AMENDMENTS TO THE DRAWINGS

This amendment is in response to the Official Action dated March 16, 2006. Claims 2-5 have been canceled, claim 1 has been amended, and claims 6-18 have been added; as such claims 1 and 6-18 are now pending in this application. Claims 1, 6 and 18 are independent claims. Reconsideration and allowance is requested in view of the claim amendments and the following remarks.

Application No. 10/521,147
Amendment dated June 18, 2007
Reply to Office Action of March 16, 2007

Docket No.: SON-2799

FIG. 6

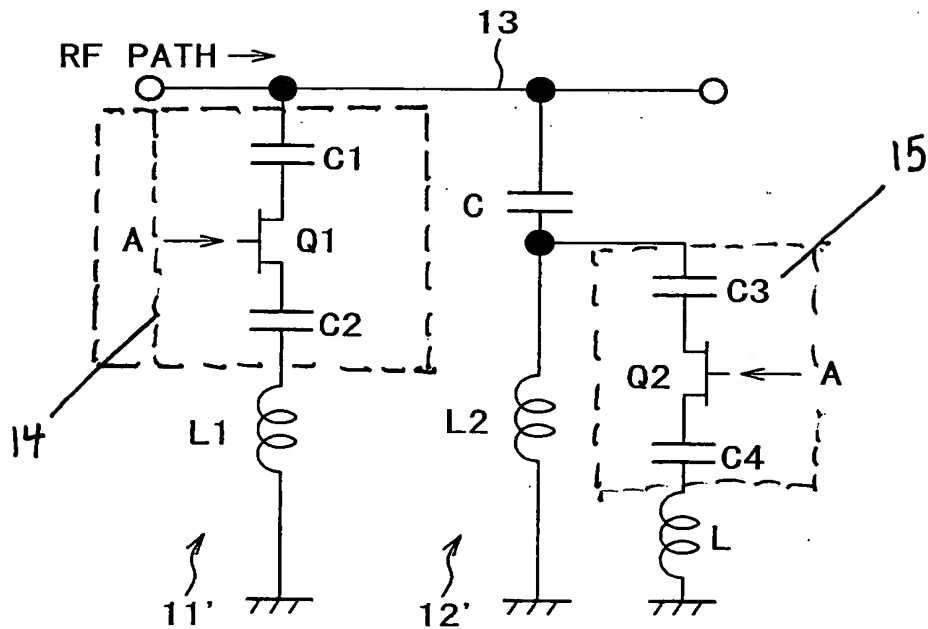
The attached sheet(s) of drawings includes changes to FIG. 6, FIG. 8, FIG. 9, FIG. 10, FIG. 12 and FIG. 13.
